SUBJECT: DONALD C. COOK NUCLEAR PLANT, UNIT NOS. 1 AND 2 - ISSUANCE OF
AMENDMENTS RE: ROD MISALIGNMENT REQUIREMENT FOR MOVABLE CONTROL
ASSEMBLIES (TAC NOS. M88765 AND M88766)

AMENDMENT NO. 193 TO FACILITY OPERATING LICENSE NO. DPR-58-D. C. COOK-UNIT 1
AMENDMENT NO. 179 TO FACILITY OPERATING LICENSE NO. DPR-74-D. C. COOK-UNIT 2

SAFETY EVALUATION BY THE OFFICE OF NUCLEAR REACTOR REGULATION
RELATED TO AMENDMENT NO. 193 TO FACILITY OPERATING LICENSE NO. DPR-58
AND AMENDMENT NO. 179 TO FACILITY OPERATING LICENSE NO. DPR-74
INDIANA MICHIGAN POWER COMPANY
DONALD C. COOK NUCLEAR PLANT, UNIT NOS. 1 AND 2
DOCKET NOS. 50-315 AND 50-316

FIGURE 3.1-4

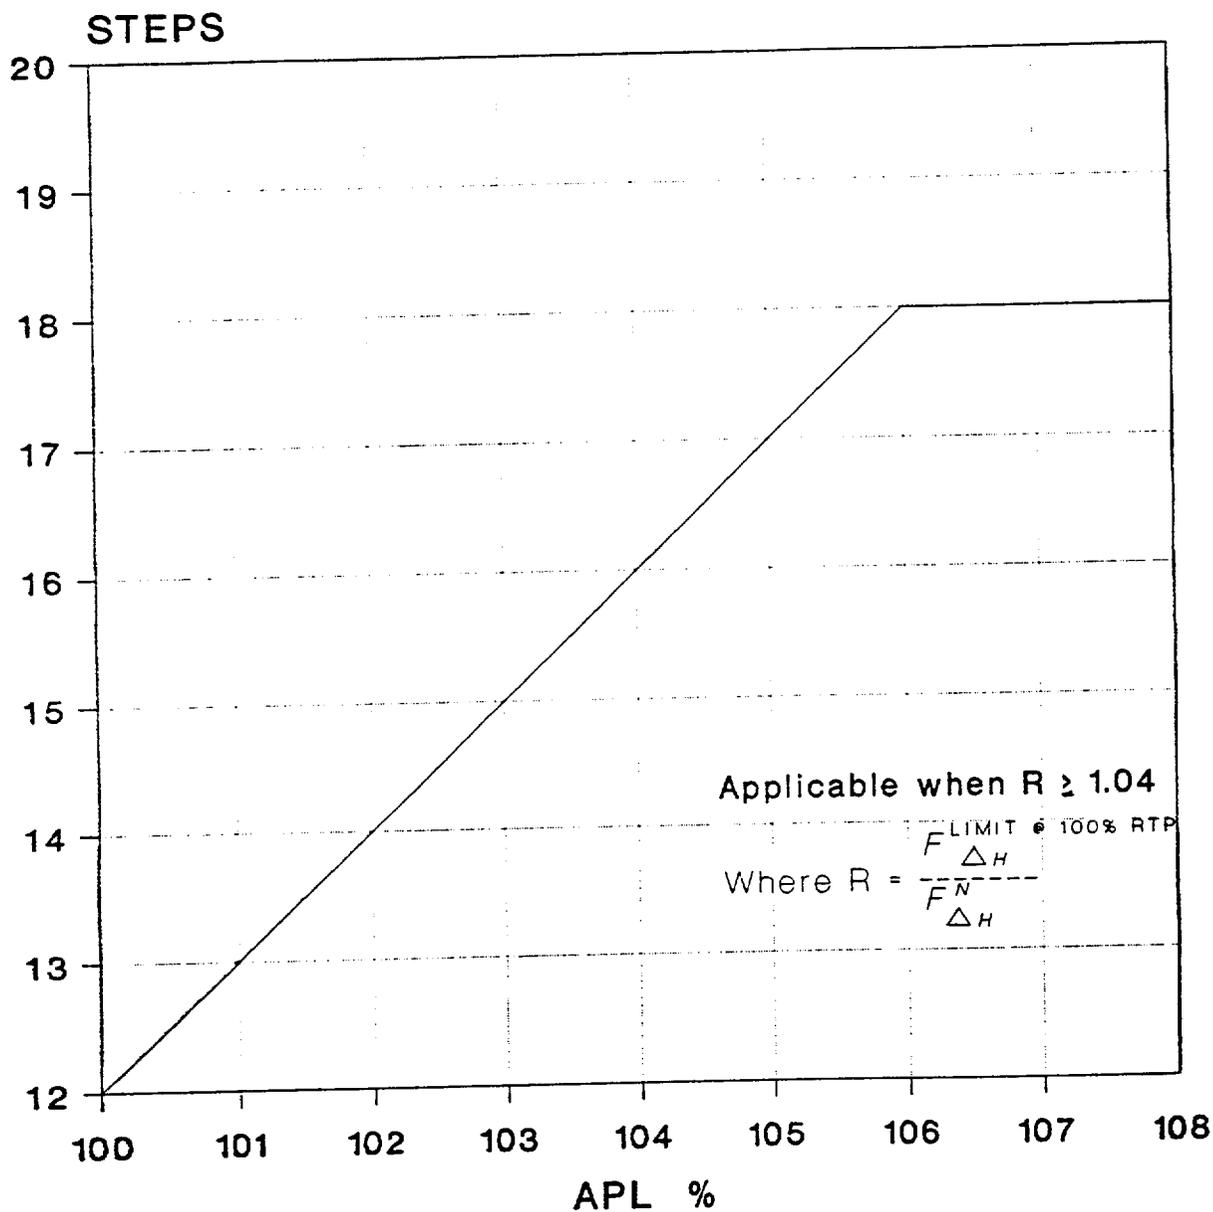
- for THERMAL POWER less than or equal to 85% of RATED THERMAL POWER, the allowed rod misalignment is ± 18 steps, and
- for THERMAL POWER greater than 85% of RATED THERMAL POWER, the allowed rod misalignment is ± 12 steps or as determined from Figure 3.1-4. Figure 3.1-4 permits an allowed rod misalignment from ± 13 steps (for APL equal to 101%) to ± 18 steps (for APL greater or equal to 106%) provided the value of R (defined in Figure 3.1-4) is greater than or equal to 1.04.

FIGURE 3.1-4

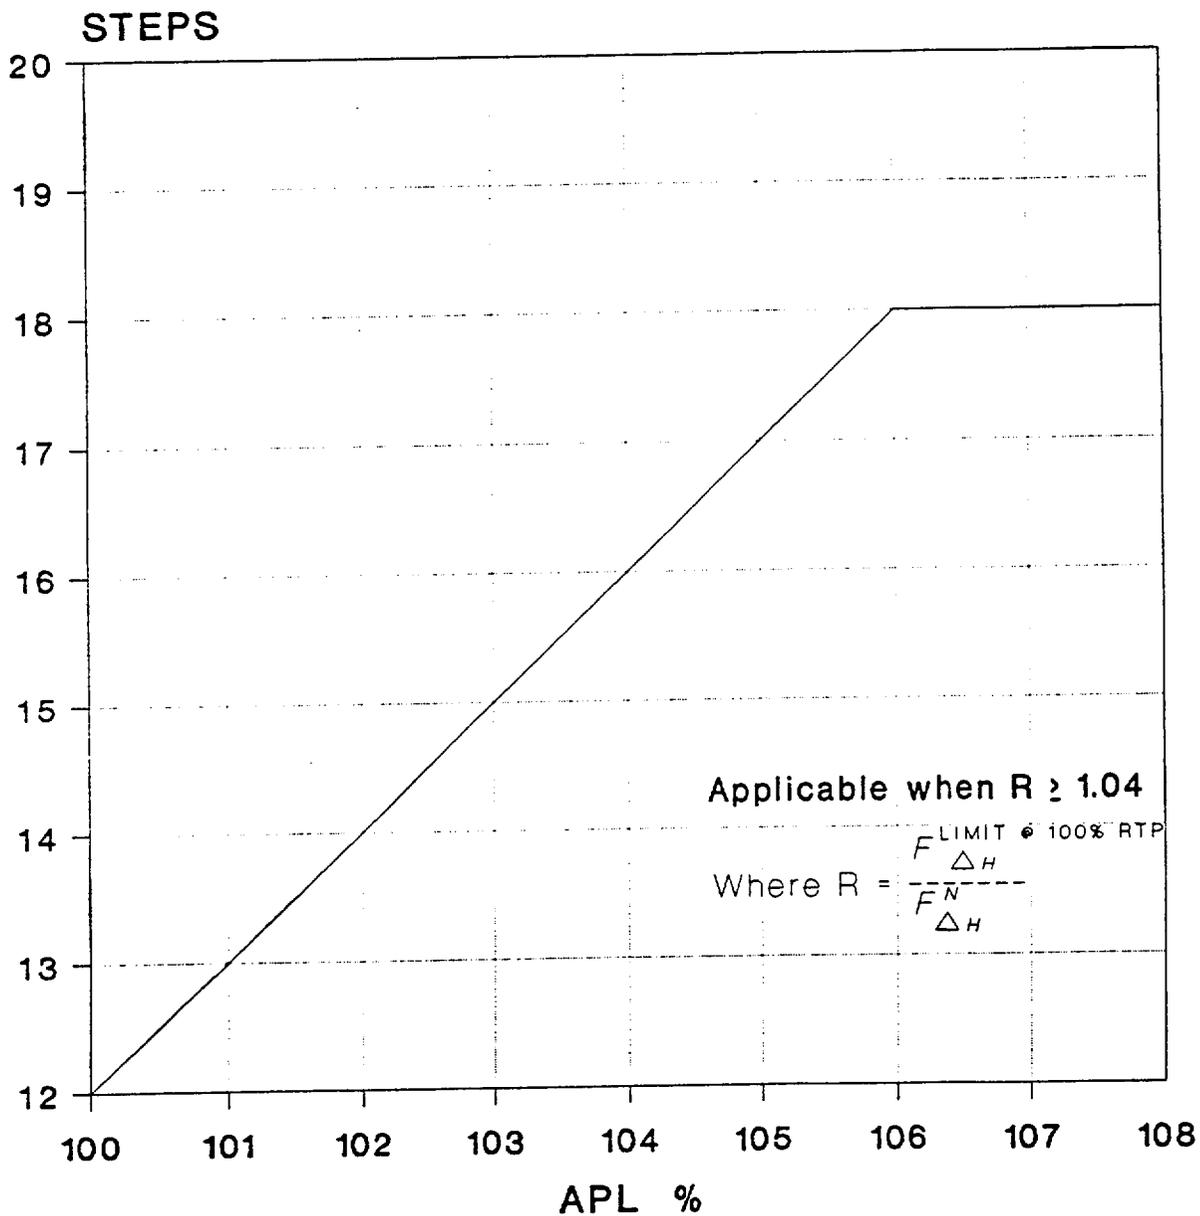
- for THERMAL POWER less than or equal to 85% of RATED THERMAL POWER, the allowed rod misalignment is ± 18 steps, and
- for THERMAL POWER greater than 85% of RATED THERMAL POWER, the allowed rod misalignment is ± 12 steps or as determined from Figure 3.1-4. Figure 3.1-4 permits an allowed rod misalignment from ± 13 steps (for APL equal to 101%) to ± 18 steps (for APL greater or equal to 106%) provided the value of R (defined in Figure 3.1-4) is greater than or equal to 1.04.
